# Rattle After Start – Upper Timing Chain – Install Revised Tensioner

MODEL 1995-96 MY  
Sedan (4.0L) Range  
VIN  
See engine no.

ILLUSTRATION 1

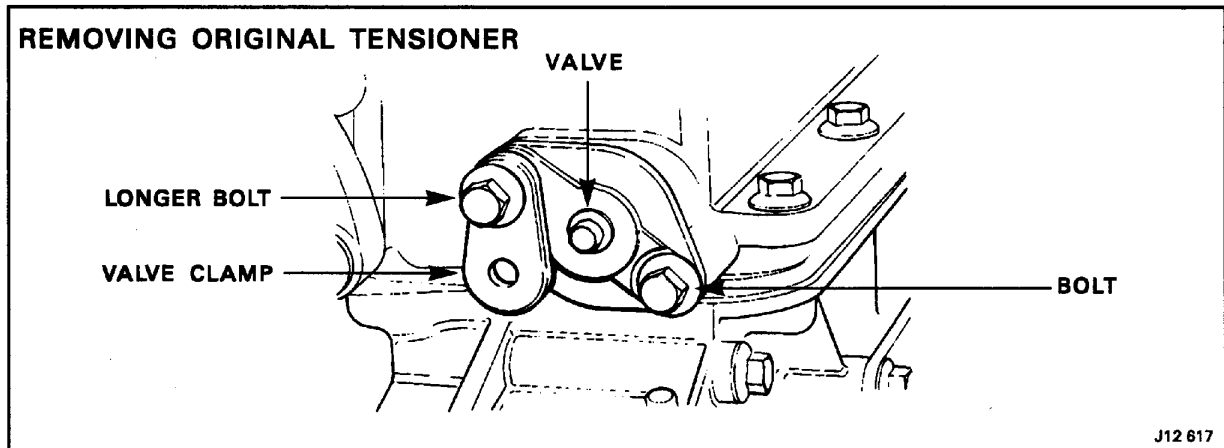
1. Remove the fuel pump relay and run the engine at idle to depressurize the fuel system.
2. Remove the longer bolt (Illustration 1), remove the valve clamp and remove the valve.

ILLUSTRATION 2

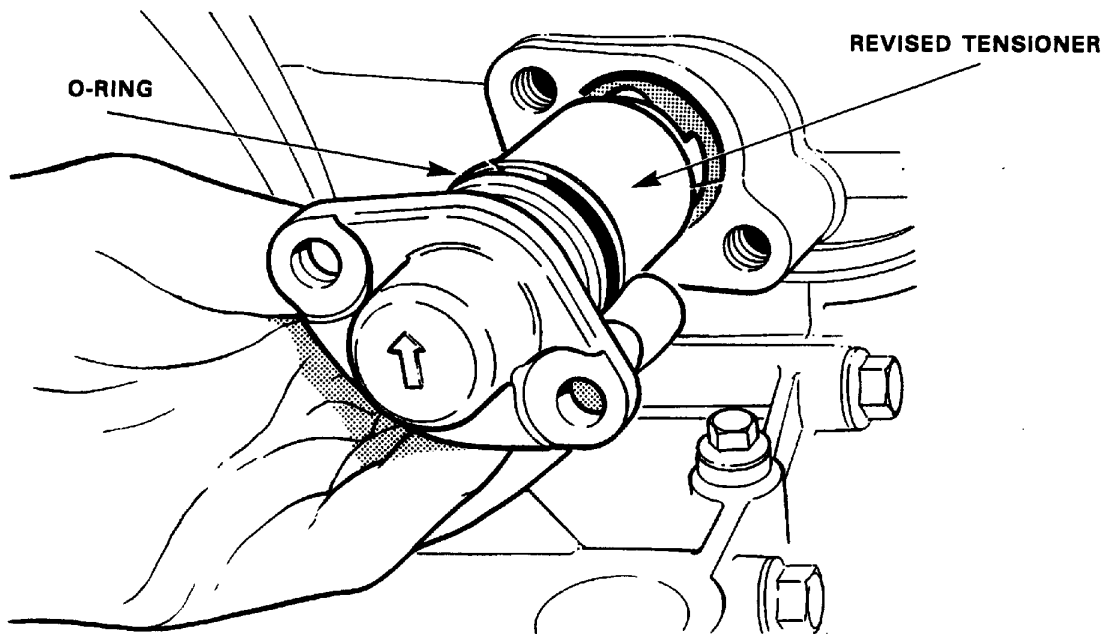
A revised tensioner with an integral oil reservoir has been introduced to overcome this condition starting with the following engine numbers:

5. Place the O-ring on the revised tensioner (Illustration 2) and lubricate it with engine oil.
6. Check that the mechanical tensioner within the piston is fully retracted (fully closed position.)
7. Install the tensioner assembly with a new gasket on the engine. Ensure that the arrow is pointing up and that the slotted head of the piston is aligned with the tensioner blade. (The bolt listed in the part information replaces the longer bolt previously discarded.) Torque the bolts to 16.2 - 20.7 lb. ft. (22 - 28 Nm.)
